CALFED Bay-Delta 2002 ERP Directed Actions -- Selection Panel Review

Proposal Number: 223DA

Proposal Title: Battle Creek Salmon and Steelhead Restoration Project

Technical Review Panel Report

Figure 3. A Schematic of the Modified Facilities and Water Diversions in the Battle Creek Basins as Described in the Preferred Alternative, Also Described as the 5-Dam Removal Alternative (Figure I-3 of the USBR's Conceptual Design Report)

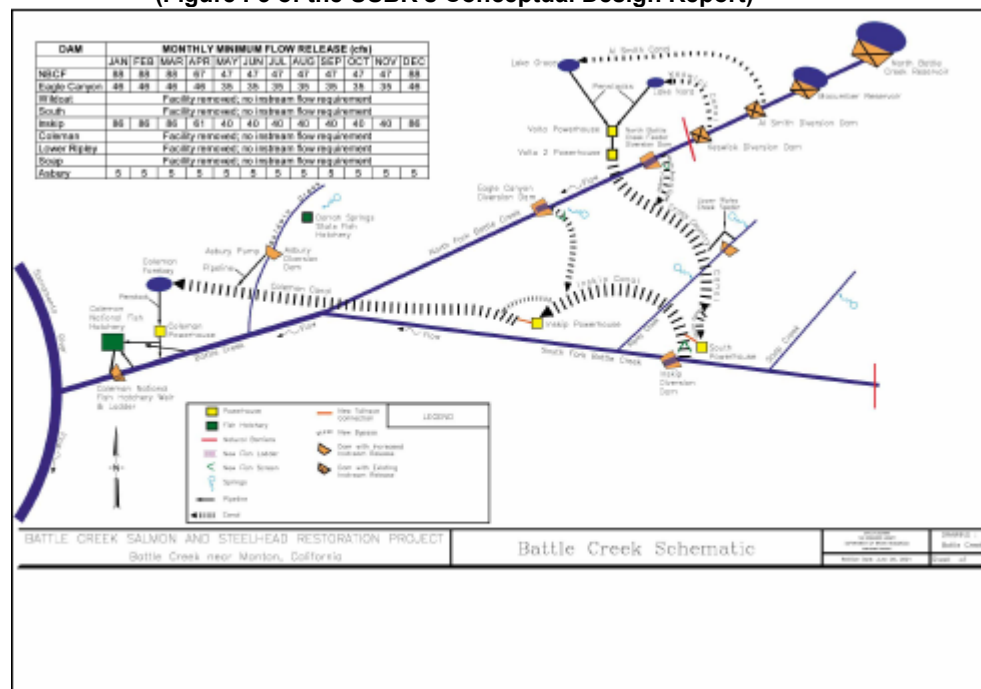
The Panel agreed that it was worth noting that the project as defined for this review does not incorporate a barrier to fish passage into the Coleman Powerhouse tailrace. The general location of this facility is illustrated on Figure 1 and Figure 2. At present, the discharge from the Coleman Powerhouse is a mix of water from North Fork and South Fork Battle Creek. With the project implemented, the discharge from the Coleman Powerhouse will consist mainly of water from the North Fork, except for some water from Baldwin Creek. Attraction of adult salmonids into the tailrace channel is currently a problem and fish are captured and transported to the mainstem.

With the project implemented, the proportion of water from the North Fork being discharged into the Coleman Powerhouse tailrace will be greater and, at certain flow regimes, can exert an even greater influence on upstream migrating adult salmonids of North Fork origin. According to the Project Technical Team, the barrier on the Coleman Powerhouse tailrace is being investigated; however, as noted above, this structure is not a part of the project defined for the Panel's review. In view of the attention given in the project configuration to prevent false attraction, the Panel feels this barrier should be scheduled and implemented as an integral part of the project.
